# UNITED STATES PATENT AND TRADEMARK OFFICE

APPLICATION NO.	FILING DATE	FIRST NAMED INVENTOR	ATTORNEY DOCKET NO.	CONFIRMATION NO.
10/553,061	04/26/2006	Thomas Roiser	4301-1147	4268
466	7590	09/11/2006	EXAMINER	
YOUNG & THOMPSON 745 SOUTH 23RD STREET 2ND FLOOR ARLINGTON, VA 22202			AMIRI, NAHID	
			ART UNIT	PAPER NUMBER
			3679

<b>Office Action Summary</b>	<b>Application No.</b>	<b>Applicant(s)</b>	
	10/553,061	ROISER, THOMAS	
	<b>Examiner</b>	<b>Art Unit</b>	
	Nahid Amiri	3679

**DETAILED ACTION*****Drawings***

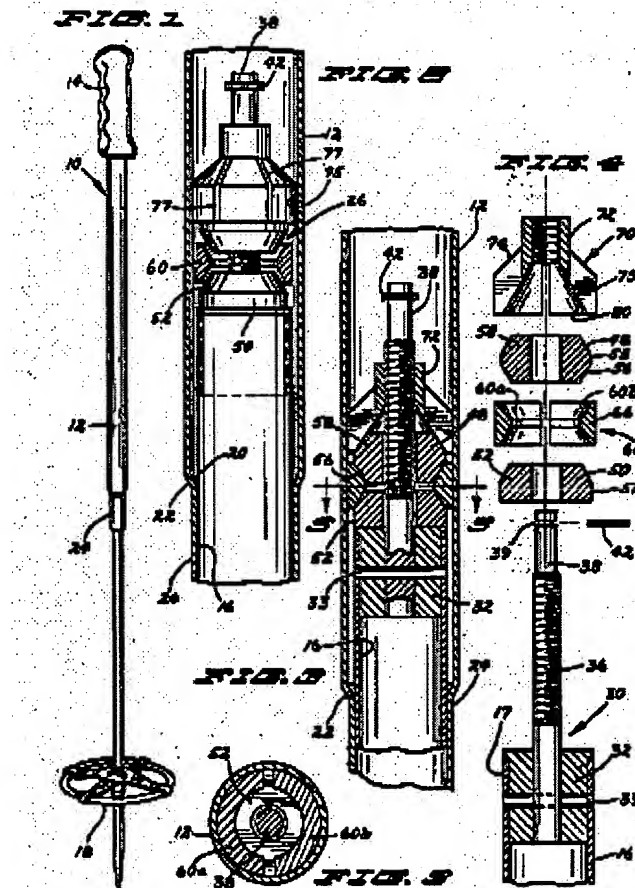
With respect to claim 13, Hinners discloses a clamping device (**Figs. 1-4, see below**) for telescoping tubes (**12, 14**), with a radially expandable clamping part (**60**) which is hollow cylinder has a continuous lengthwise slot, conical expansion bodies (**50, 70**) being assigned to

the two ends characterized in that the expansion bodies (50, 70) can be moved relative to the clamping part (60), and are screwed onto threaded sections (constituted by the upper and lower sections of threaded 36), of the threaded rod (30) with opposing threads, and that a threaded part (30) which has a threaded rod (30) is attached to the inner tube of the telescoping tubes (12, 14).

With respect to claims 15-17, Hinners discloses (Fig. 5, see above) that the hollow cylinder (60) which forms the clamping part has recesses (constituted by space between parts 60a and 60b) which proceed from its two ends; wherein the two recesses are diametrically opposite one another on each end of the hollow cylinder (60).

With respect to claim 18, Hinners discloses (Fig. 2, above) that the expansion bodies (50, 70) with their ends of smaller diameter engage the clamping part (60).

With respect to claim 19, Hinnars discloses (**Fig. 2, above**) that the expansion bodies (**50, 70**) their ends with the greater diameter are made to increase friction relative to the material of the outer tube (**12**).

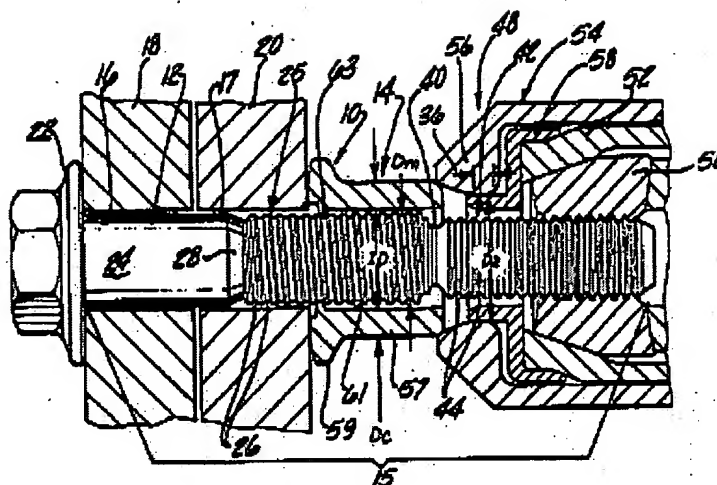
With respect to claim 14, Hinnars discloses the claimed invention except that the threaded section of the screw that is adjacent to the inner tube has a greater diameter than the threaded section which is remote from the inner tube. Dixon teaches a clamping device (**10, Figs. 1-2, see below**) including a screw (**12**) having a first threaded portion (**25**), which has greater diameter, than a second threaded portion (**24**). It would have been obvious to one of ordinary skill in the art at the time of invention was made to modify the screw of Hinnars to have a first threaded section with a greater diameter than a second threaded section as taught by Dixon in order to clamp two members together at a preselected preload by the axial force initially applied between the screw and collar.
